RI Work Plan for the Automotive Repair Shop (716-A) OU (U)

Savannah River Site
January-May 2024

Executive Summary, Page ES-6 of ES-6

Figure ES-2. Proposed Soil Sampling Locations at Building 716-A

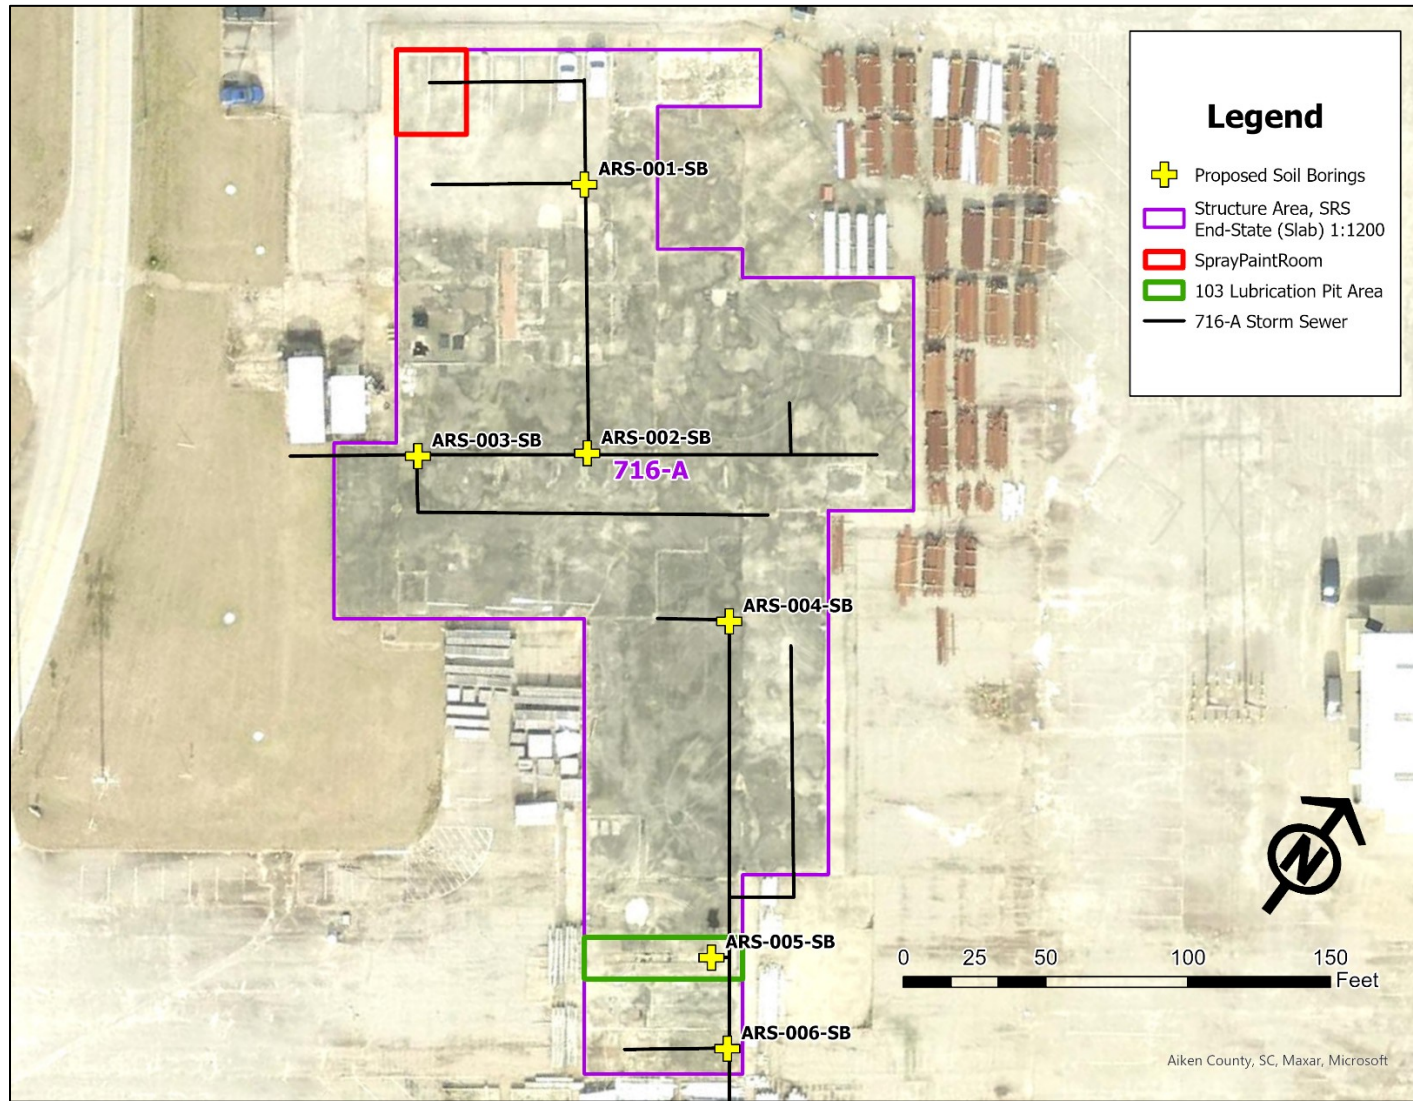
- Sampling is proposed at ~~five~~ six soil boring locations to determine if there has been a release to the environment beneath the concrete slab (Figure ES-2). Samples will be collected from continuous soil cores from each boring, and lithologic descriptions will be recorded. ~~The four~~ five locations (ARS-001-SB, ARS-002-SB, ARS-003-SB, ~~and~~ ARS-004-SB, and ARS-006-SB) beneath the drain lines and/or sewer lines will be continuously cored to a total depth of 15 meters (50 feet) below ground surface, and samples will be collected every 2 meters (5 feet) through 15 meters (50 feet). Additionally, the 103 Lubrication Pit location (ARS-005-SB) will

Figure 10. Proposed Soil Sampling Locations at Building 716-A

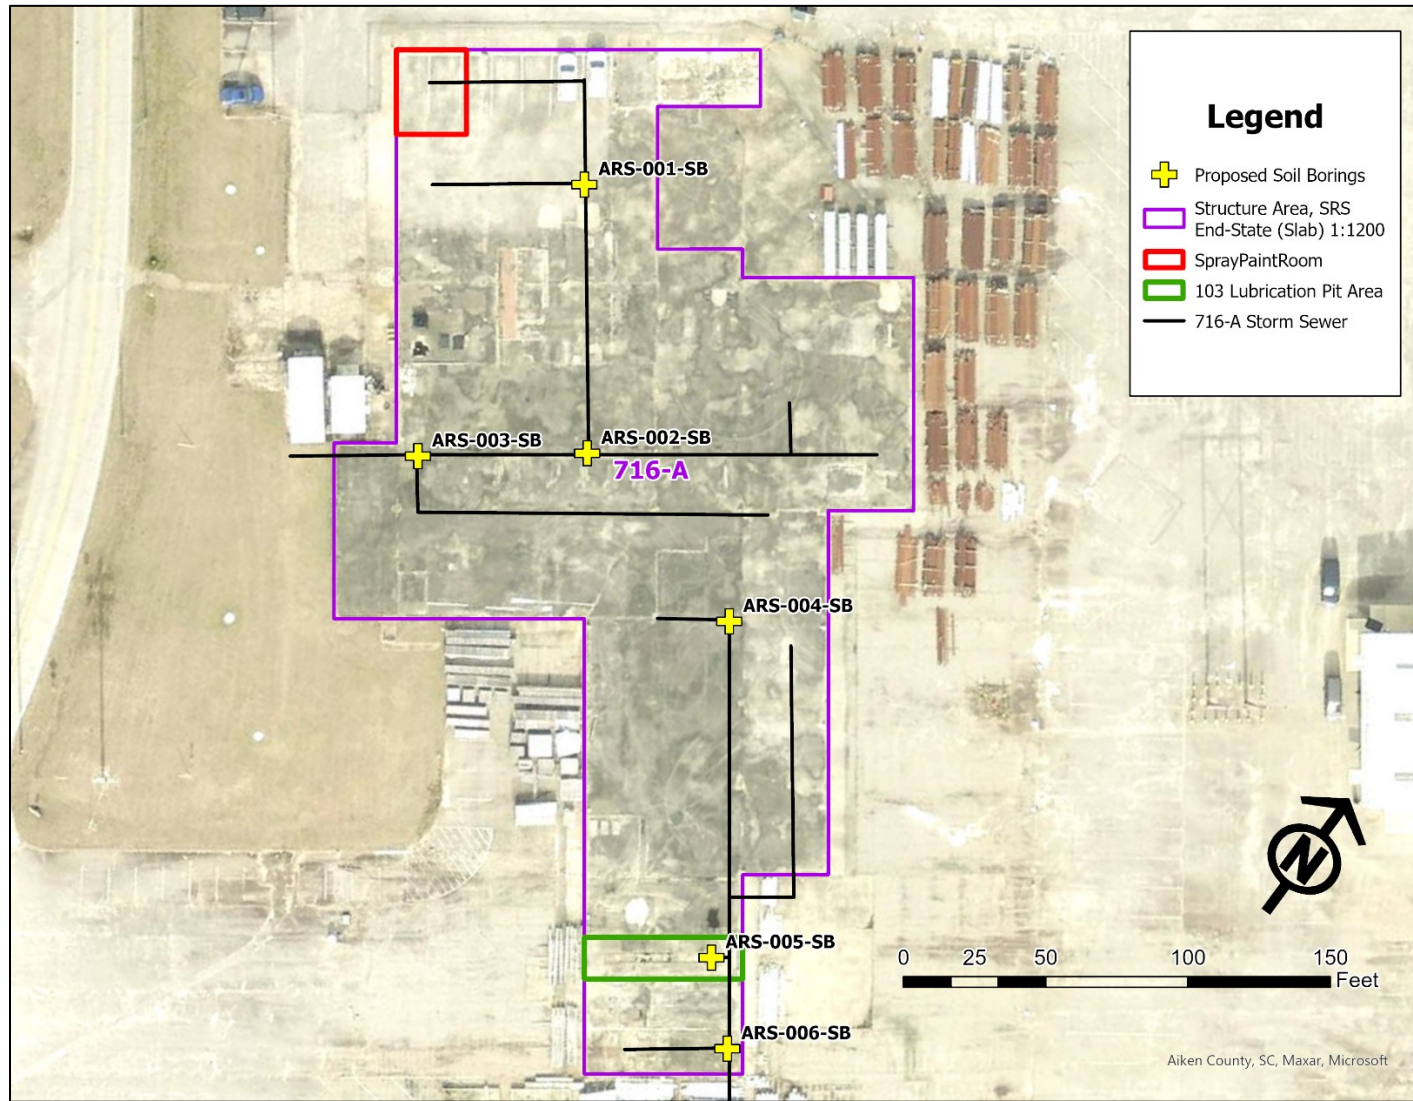
Characterization through soil sampling is warranted in this RI work plan. Soil sampling is proposed beneath the Building 716-A remnant concrete slab at the 103 Lubrication Pit and beneath the drain lines and/or sewer lines. A total of ~~five~~ six locations have been identified for sampling. Samples will be collected from continuous soil cores from each boring, and lithologic descriptions will be recorded. The ~~four~~ five locations (ARS-001-SB, ARS-002-SB, ARS-003-SB, ~~and~~ ARS-004-SB, and ARS-006-

SB) beneath the drain lines and/or sewer lines will be continuously cored to a total depth of 15 m (50 ft) bgs, and samples will be collected every 2 m (5 ft) through 15 m (50 ft). Additionally, the 103 Lubrication Pit location (ARS-005-SB) will be continuously cored to a total depth of 49 m (160 ft) bgs, and samples will be collected every 2 m (5 ft) through 15 m (50 ft) and every 3 m (10 ft) thereafter to total depth. The proposed sampling is summarized in Table 2.
